Access Compliance Report

Public Rights-of-Way

Intersection ID: 27350	Main Street: BALLANVILLA_DR	Cross Street: BALLANTYNE_TRACE_CT	Location: SE
ADA ID: F1D5774B324A	Ramp Type: PerpDiag	Initial Pass/Fail: Fail	Overall Compliance: No
Severity Score: 18.75			
Codes/Mitigation Info/Possible Solution		Field Measurements/Component Compliance

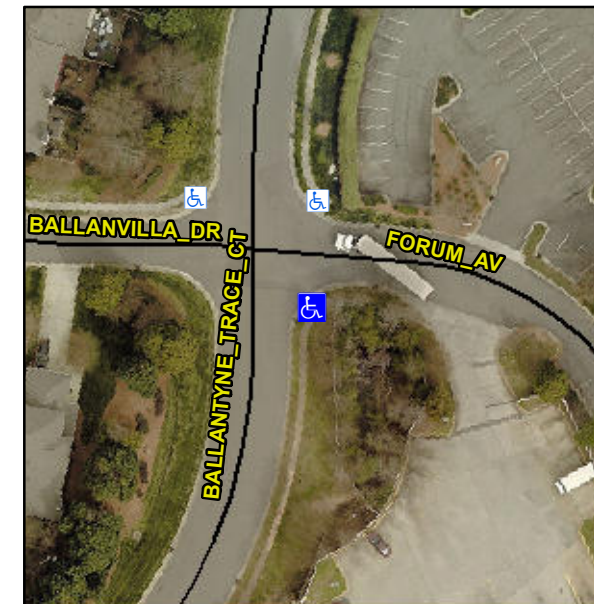
Not Found, R304.5.1, R304.5.3

Compliance	Description	Data	Compliance	Description	Data
N/A	Ramp Length (in)	96.0	Yes	Ramp Slope (%)	7.5
No	Ramp Width (in)	33.5	No	Ramp XSlope (%)	2.3
N/A	Flare Type LT	N/A	N/A	Flare Type RT	N/A
N/A	Flare Slope LT (%)	N/A	N/A	Flare Slope RT (%)	N/A
N/A	Flare Traversable LT?	N/A	N/A	Flare Traversable RT?	N/A
N/A	Landing Length (in)	N/A	N/A	DWS Provided?	N/A
N/A	Landing Width (in)	N/A	N/A	DWS Contrast?	N/A
N/A	Landing Slope (%)	N/A	N/A	DWS Length (in)	N/A
N/A	Landing X Slope (%)	N/A	N/A	DWS Full Width?	N/A
N/A	Landing Curb? (Y/N)	N/A	N/A	DWS Offset (in)	N/A
N/A	Shared Landing?	N/A			
N/A	Gutter Ponding?	N/A	N/A	Gutter Slope (%)	N/A
N/A	Gutter Lip Ht (in)	N/A	N/A	Gutter X Slope (%)	N/A
N/A	Painted X Walk1?	No	N/A	Painted X Walk2?	No
	X Walk 1 Direction	To N		X Walk 2 Direction	To W
N/A	X Walk 1 Width (in)	N/A	N/A	X Walk 2 Width (in)	N/A
	X Walk 1 Slope (%)	3.1		X Walk 2 Slope (%)	1.1
	X Walk 1 X Slope (%)	1.2		X Walk 2 X Slope (%)	2.5

Remove & Replace Curb Ramp With Two New Directional Ramps or Equivalent.
